UNITED STATES  
NUCLEAR REGULATORY COMMISSION  
WASHINGTON, D.C. 20555-0001

SUBJECT: TECHNICAL REVIEW: U.S. DEPARTMENT OF ENERGY  
DOCUMENTATION RELATED TO TANK 12H GROUTING  
OPERATIONS WITH EMPHASES ON SPECIFICATIONS, TESTING,  
RECOMMENDATIONS AND PLACEMENT PROCEDURES  
(PROJECT NO. PRO0734)

Technical Review of Documents Related  
to Tank 12H Grout Formulations,  
Testing, Procedures, and Operations at the  
H-Area Tank Farm at the Savannah River Site

# **Technical Review of Documents Related to Tank 12H Grout Formulations, Grout Testing, Procedures, and Grouting Operations at the H-Area Tank Farm at Savannah River Site (Supplement to Technical Review Report on Tank 16H and 12H [ML16231A444])**

Figure 5.10a. Particle size distributions of various GGBFS materials in terms of volumetric statistics.

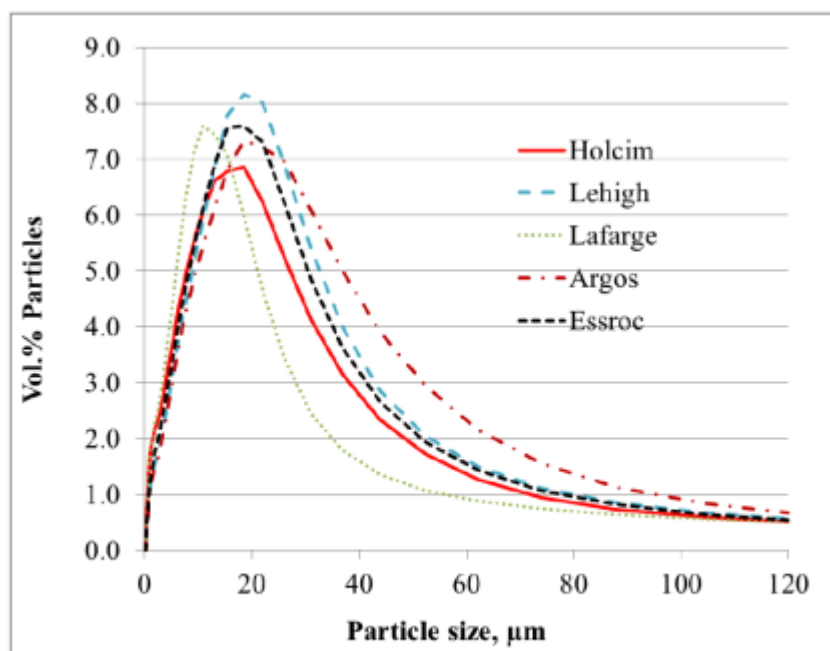
Although DOE's position has been that the hydraulic conductivity of tank grout would not be impacted by the change in slag Grade (SRR-CWDA-2015-00057), Grade 120 slag may produce a grout with a lower hydraulic conductivity than assumed in the HTF PA, which in turn may enhance rapid bypass of infiltrating water around the grout mass rather than through it. CNWRA experimental work with synthetic saltstone samples comprised of Lehigh Grade 120 slag had lower hydraulic conductivity than synthetic saltstone comprised of Holcim Grade 100 slag, resulting in longer residence times for sSRS water in the matrix and enhanced diffusive release of Tc-99 from the simulated waste form (ADAMS Accession No. ML20289A873),
